Access Compliance Report

Public Rights-of-Way

(Curb Ramps)

Intersection ID: 30613	Main Street: GOLF_LINKS_DR	Cross Street: PROVIDENCE_RD	Location: NE
ADA ID: CC0F7375E97B	Ramp Type: Perp	Initial Pass/Fail: Fail	Overall Compliance: No
Codes/Mitigation Info/Possible Solution			Severity Score: 10
			Field Measurements/Component Compliance

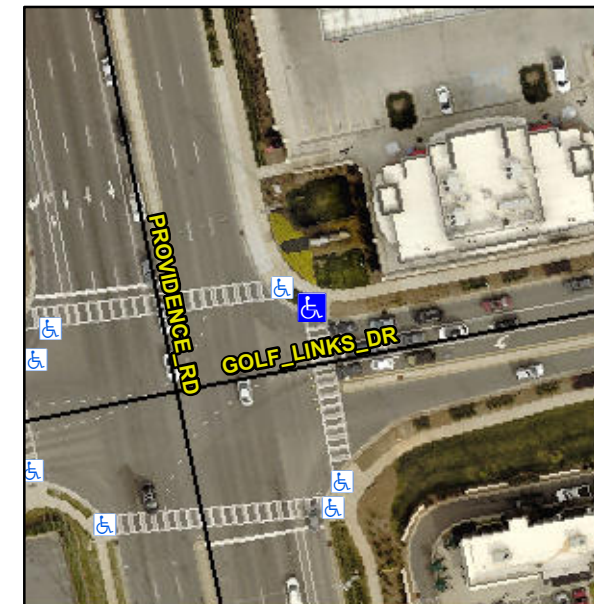
Not Found, R304.5.1, R304.5.3

Compliance	Description	Data	Compliance	Description	Data
N/A	Ramp Length (in)	96.0	Yes	Ramp Slope (%)	7.2
No	Ramp Width (in)	47.5	No	Ramp XSlope (%)	3.0
N/A	Flare Type LT	N/A	N/A	Flare Type RT	N/A
N/A	Flare Slope LT (%)	N/A	N/A	Flare Slope RT (%)	N/A
N/A	Flare Traversable LT?	N/A	N/A	Flare Traversable RT?	N/A
N/A	Landing Length (in)	N/A	N/A	DWS Provided?	N/A
N/A	Landing Width (in)	N/A	N/A	DWS Contrast?	N/A
N/A	Landing Slope (%)	N/A	N/A	DWS Length (in)	N/A
N/A	Landing X Slope (%)	N/A	N/A	DWS Full Width?	N/A
N/A	Landing Curb? (Y/N)	N/A	N/A	DWS Offset (in)	N/A
N/A	Shared Landing?	N/A			
N/A	Gutter Ponding?	N/A	N/A	Gutter Slope (%)	N/A
N/A	Gutter Lip Ht (in)	N/A	N/A	Gutter X Slope (%)	N/A
N/A	Painted X Walk1?	No	N/A	Painted X Walk2?	N/A
	X Walk 1 Direction	To S		X Walk 2 Direction	N/A
N/A	X Walk 1 Width (in)	N/A	N/A	X Walk 2 Width (in)	N/A
	X Walk 1 Slope (%)	2.2		X Walk 2 Slope (%)	N/A
	X Walk 1 X Slope (%)	1.4		X Walk 2 X Slope (%)	N/A

Remove & Replace Entire Ramp.
